V8 XJ Series/XK

204-S499

TECHNICAL BULLETIN

Lower Wishbone Front Bushing –
Change Of Specification –
Service Action S499MODEL
1999-2000 MY XK Range
1999-2000 MY V8 XJ Series
VIN
034426-A06104
862295-F11235Remove and destroy Bulletin 204-S499, dated 04/03.
Replace with this Bulletin.
Revisions are marked with a bar and in **bold text**.**Issue:**

ILLUSTRATION 1

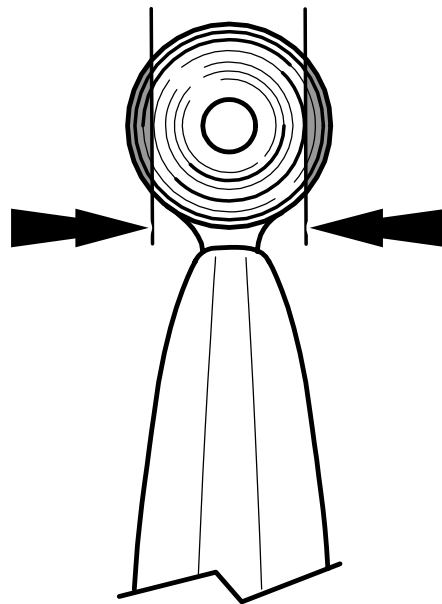
IDENTIFICATION RIB ON MNE 1360BB BUSHING

1. **Raise vehicle on ramp.**
2. **Inspect the front wishbone bushings. A raised circular rib around the circumference of the center steel core identifies the MNE 1360BB level bushing (Illustration 1).**

Note: If the MNE 1360BB level bushing is installed, no further action is required. If any other level of bushing is installed, continue with the procedure below to install MNE 1360BB level bushings.

ILLUSTRATION 2

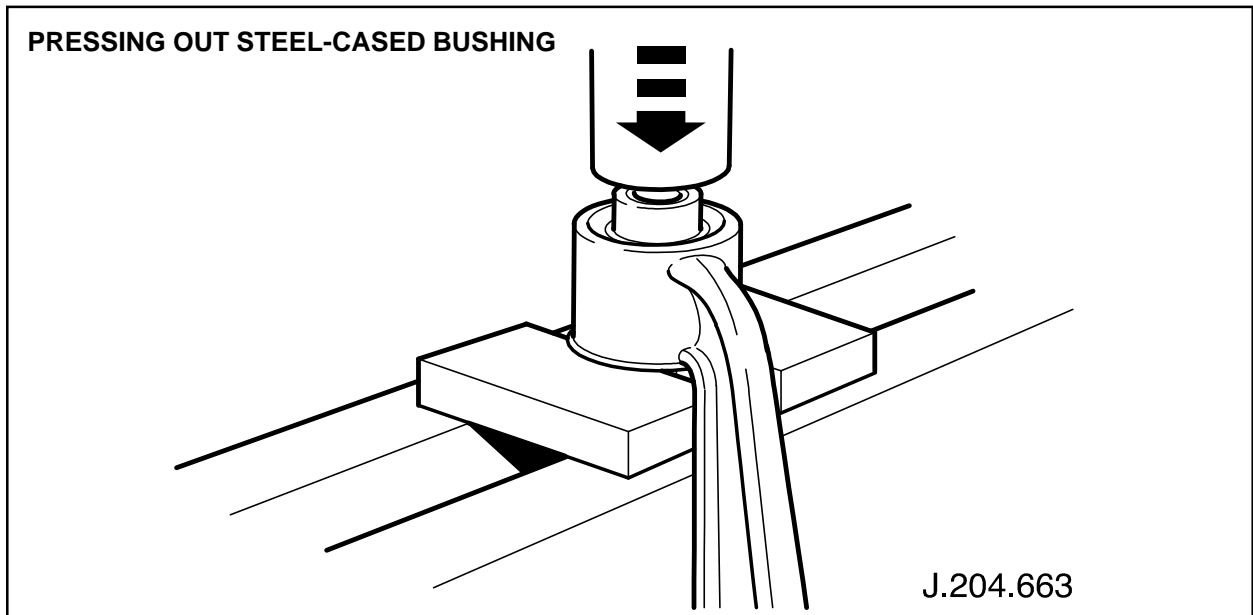
"HALF-MOON" CUTS ON STEEL-CASED BUSHING

1. Disassemble the front suspension as necessary, as detailed in JTIS, Section 204, **SRO 60.35.45 for XK vehicles, SRO 60.35.56 for V8 XJ Series vehicles. If removing steel-cased bushings continue procedure with step 2 below.**
2. Make 2 saw cuts through the rubber and **partly** into the flange of the steel casing, at the locations shown in Illustration 2, in line with the casing of the bush.

⚠ Caution: Do **not** cut **fully** through the steel flange. The sawcuts should penetrate through only 75 - 80 % of the thickness of the steel flange, so that the saw blade does not contact the wishbone arm.

3. Position the wishbone arm on the support plates of the hydraulic press, so that the bushed end is supported by the plates where the 'half-moons' have been removed. This will allow the casing of the displaced bush to pass between the support plates (Illustration 3).

4. Using Special Tool 204-214, press the bush from the bore in the wishbone arm.
